Accessibility Survey

City of Downey Cheyenne Street - Barlin Avenue To Blodgett Avenue

Date of Inspection
4/7/2017

Disability Access Consultants

Change In Level East Of Laureldale Avenue @ 33.913535708294, - 118.146736621857

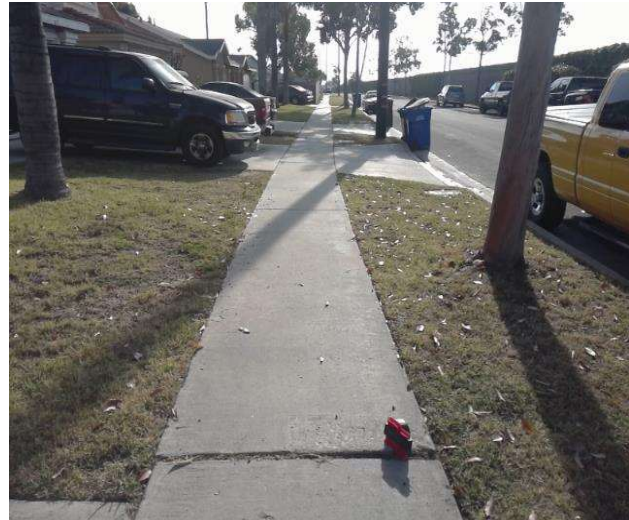
There is a change in elevation greater than recommended value.

On-Site Finding 0.50 inches

Ensure that the change in elevation is within the recommended value.

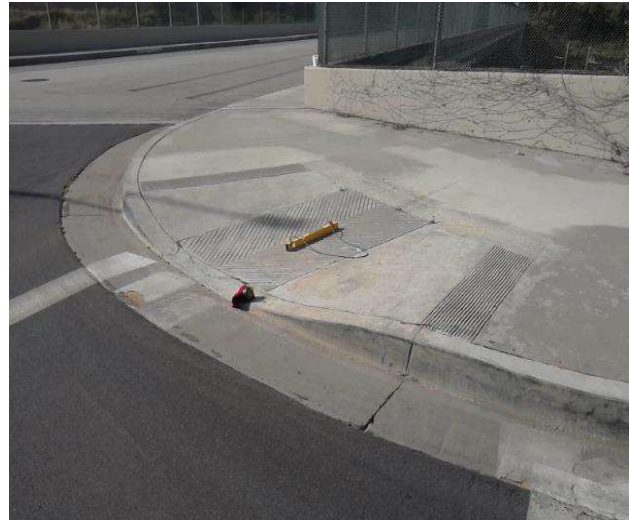
The curb ramp does not provide a detectable warning surface which includes truncated domes.

On-Site Finding Not Found

Provide compliant detectable warnings to surface.

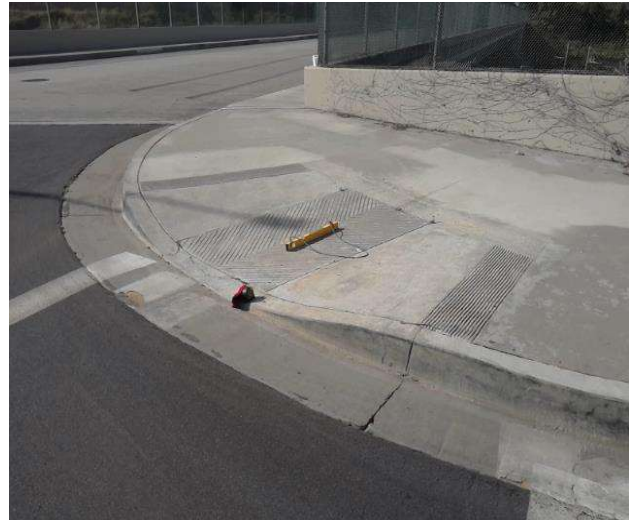
The slope of the curb ramp side flare is greater than allowed.

On-Site Finding 12.90 percent

Provide curb ramp side flares with a compliant slope.

Curb Ramp , Landings And Transitions : Bottom Landing Change in Level

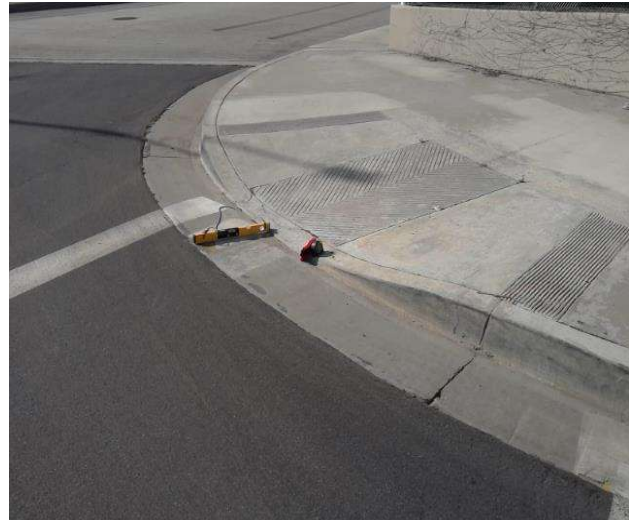
On-Site Finding 0.75 inches

Patch the transition area at the bottom of the curb ramp so that the transition is flush and free of abrupt changes.

Recommendation Up to 0.50 inches
